WHC-SD-WM-ER-124 Revision 1

The 242-A Evaporator/ Crystallizer Tank System Integrity Assessment Report

H	
ENGINEERING CHANGE NOTICE		1. ECN	608025
ENGINEERING CHANGE NOTICE	Page 1 of	Proj. ECN

Incorporate potential regulatory compliance deficiencies Justification:

Figure 18. Pump Room Sump Schematic (Evaporator Building floor drains to the sump via 1 1/2 - 3 in. drain lines and a 10 in. overflow line flows by gravity to the AW-102 Feed Tank The sump is 5 ft x 5 ft x 6 ft deep).

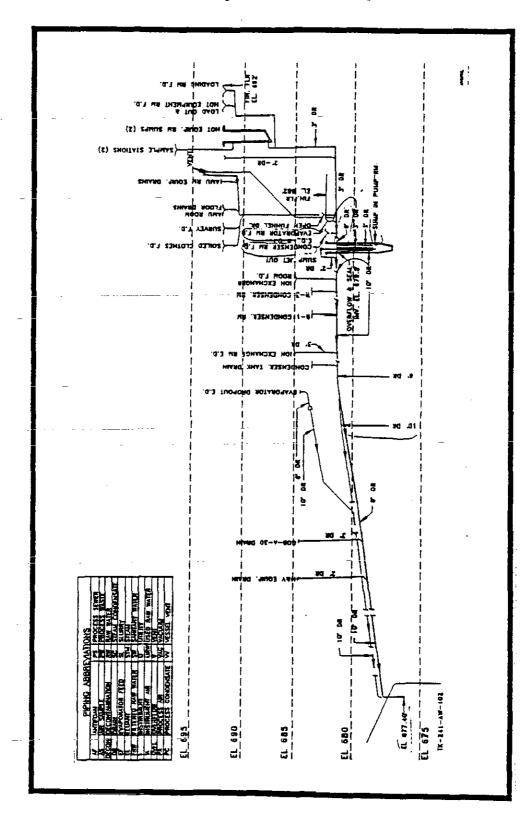
The pump room sump may not comply with WAC 173-303-640(4) requirements for secondary containment.

The pump room sump is alarmed with weight factor (differential pressure) level indication for leak detection and liquid in the sump can be jetted to a double shell tank farm in the event of a leak in the Evaporator/Crystallizer system. However, the liquid seal maintained between the Evaporator/Crystallizer and the feed tank in the pump room sump is assumed to be contaminated with dangerous waste(s). A 0.25 in (0.63 cm) SS liner inserted in 24 in (61 cm) of concrete provides a single boundary containment of this liquid.

The pump room sump may not comply with WAC 173-303-640(4) requirements for secondary containment.

The pump room sump is alarmed with weight factor (differential pressure) level indication for leak detection and liquid in the sump can be jetted to a double shell tank farm in the event of a leak in the Evaporator/Crystallizer system. However, the liquid seal maintained between the Evaporator/Crystallizer and the feed tank in the pump room sump is assumed to be contaminated with dangerous waste(s). A 0.25 in (0.63 cm) SS liner inserted in 24 in (61 cm) of concrete provides a single boundary containment of this liquid.

CORRECTIVE ACTION:

Perform an engineering study to identify options for pump room sump compliance. The study should consider costs and benefits (including ALARA) of system upgrades to include secondary containment for the sump or redesign of the liquid seal versus a formal petition for equivalent secondary containment.
